CALIFORNIA INSTITUTE OF TECHNOLOGY MASSACHUSETTS INSTITUTE OF TECHNOLOGY		NAME		RACK & CABLE TRAY LAYOUT, LVEA, H1 & H2 – Tray Lengths	
		DESIGNER	D. COYNE	2010-11-16	SIZE
DRAFTER	D. COYNE	2010-11-16	E	D1002704	
CHECKER					REV
FOR APPROVAL SEE THE DCC RECORD			SCALE:	PROJECTION:	SHEET 4 OF 5

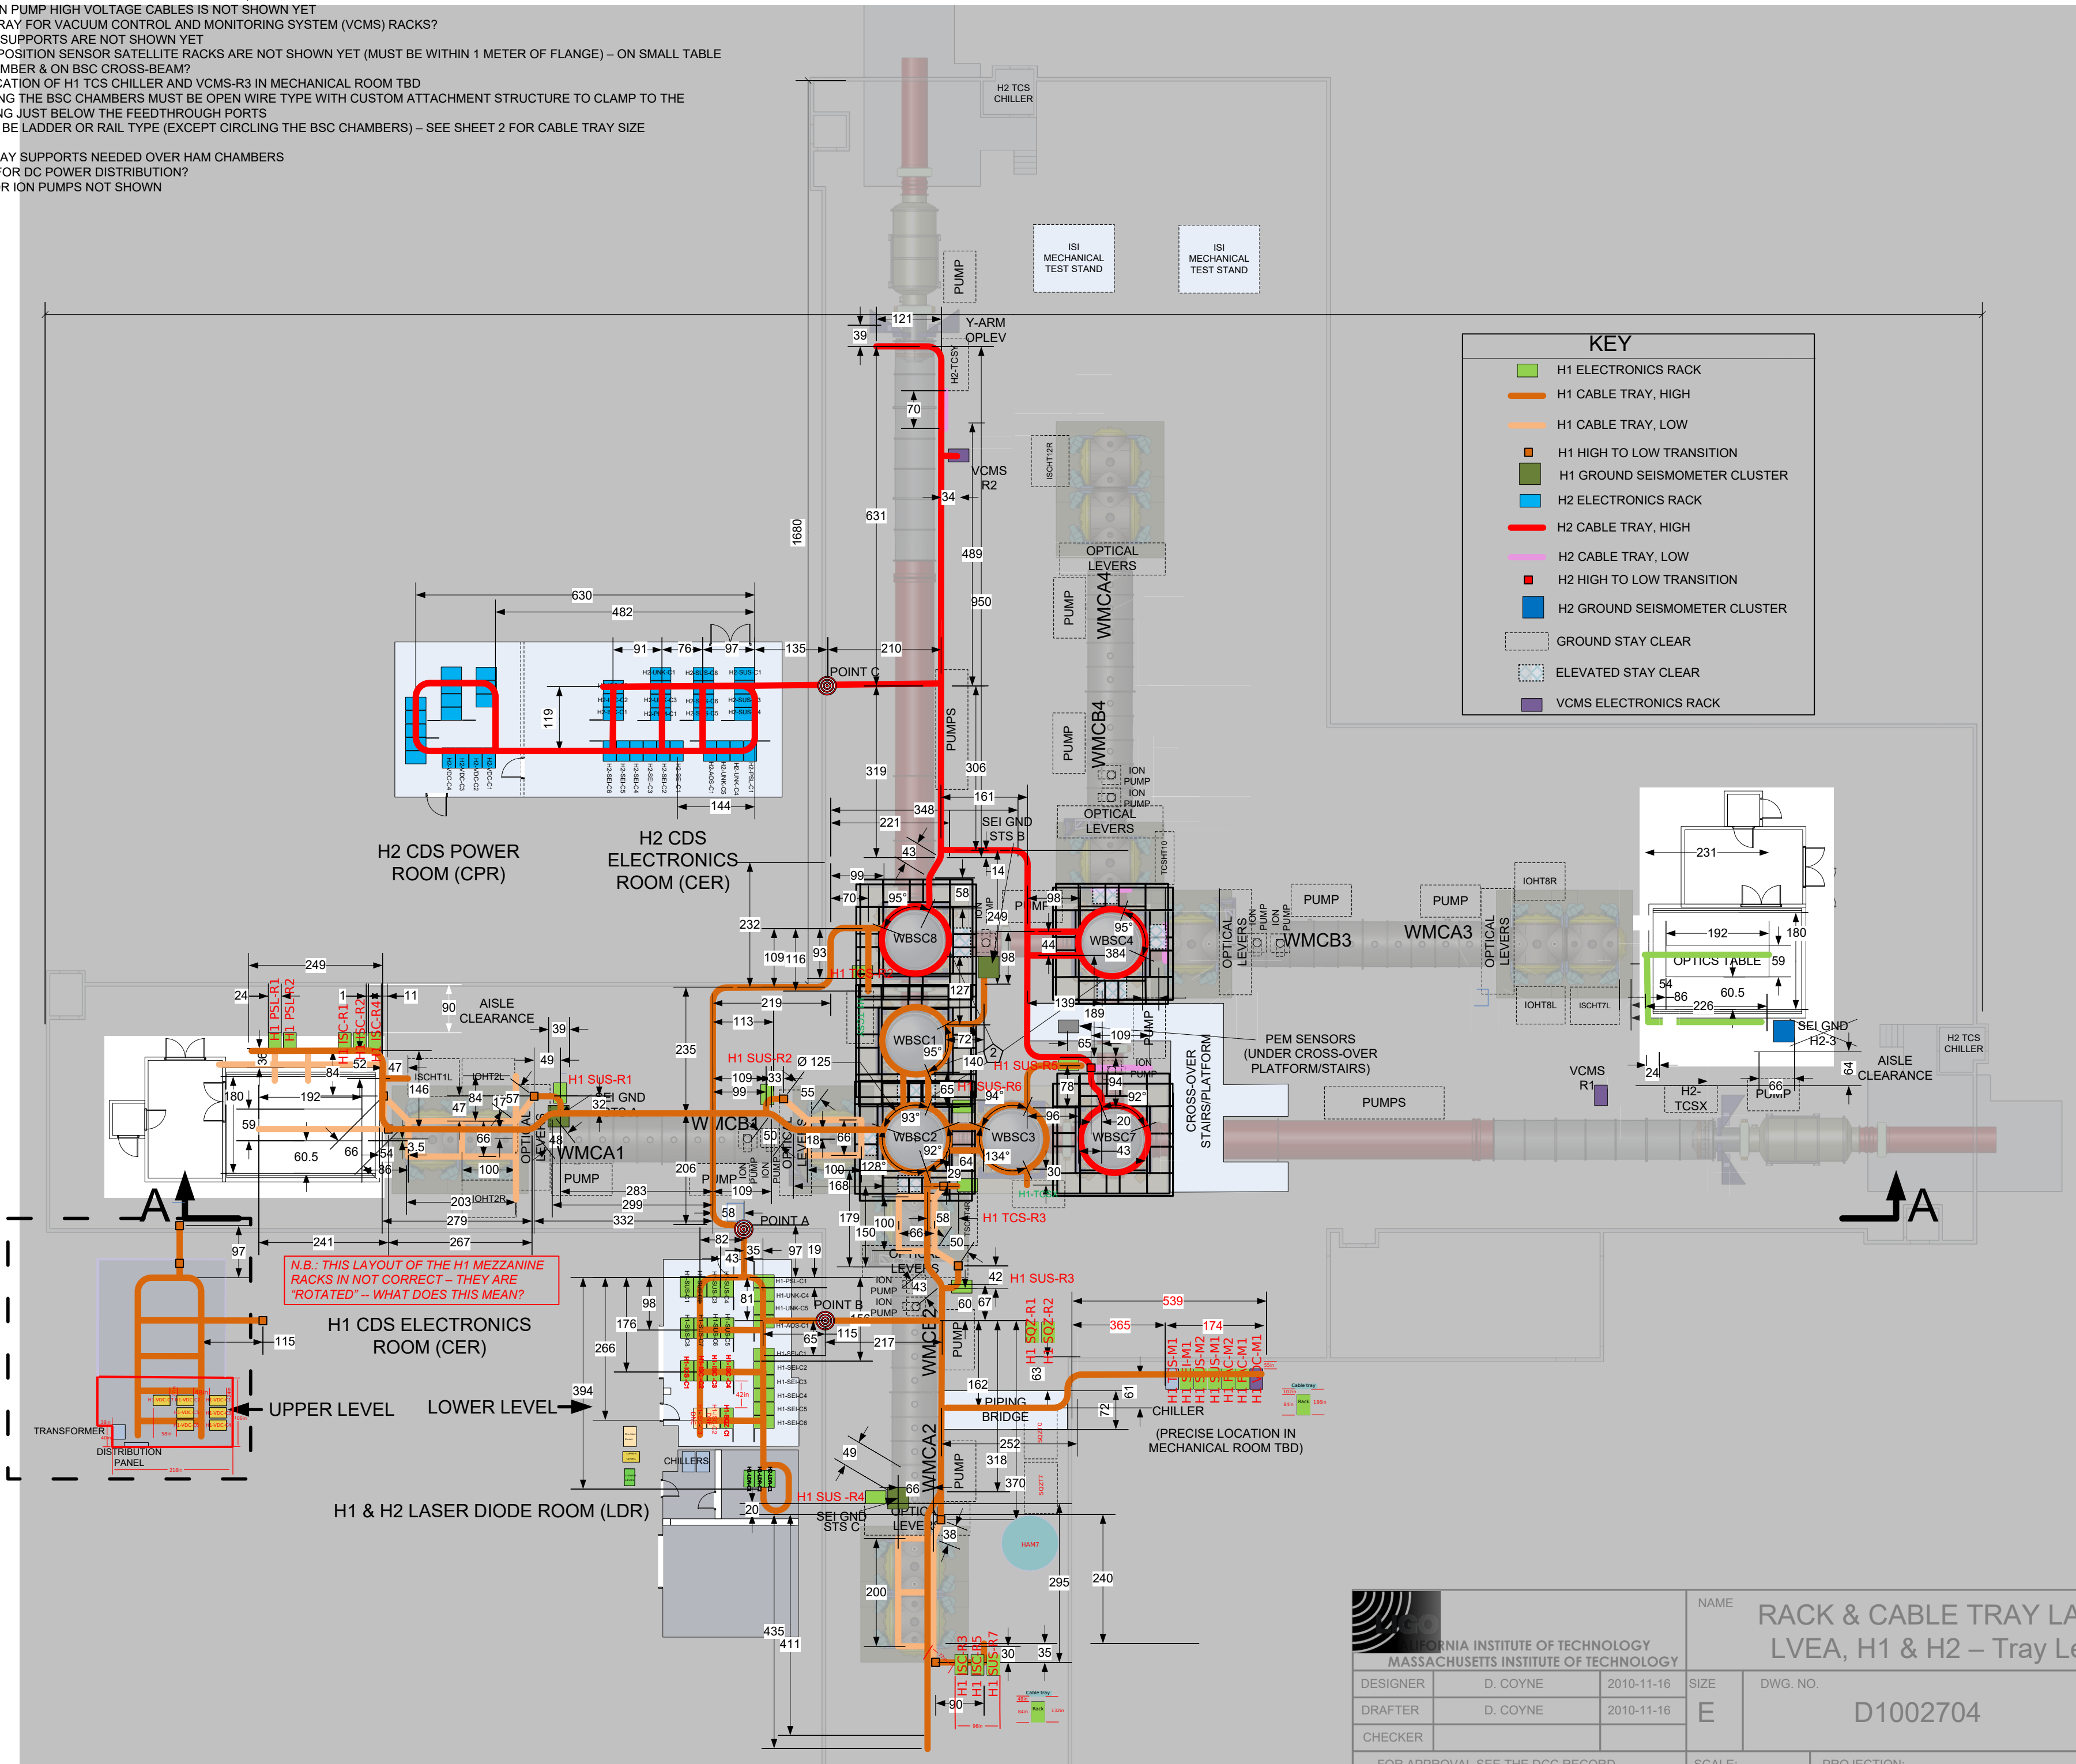
- 4) SEPARATE TRAY FOR VACUUM CONTROL AND MONITORING SYSTEM (VCMS) RACKS?
 - 5) CABLE TRAY SUPPORTS ARE NOT SHOWN YET
 - 6) CAPACITIVE POSITION SENSOR SATELLITE RACKS ARE NOT SHOWN YET (MUST BE WITHIN 1 METER OF FLANGE) – ON SMALL TABLE NEAR HAM CHAMBER & ON BSC CROSS-BEAM?

- 11) CONDUITS FOR DC POWER DISTRIBUTION?
 - 12) HV TRAY FOR ION PUMPS NOT SHOWN

N.B.: THIS LAYOUT OF THE H1 MEZZANINE RACKS IS NOT CORRECT – THEY ARE "ROTATED" – WHAT DOES THIS MEAN?
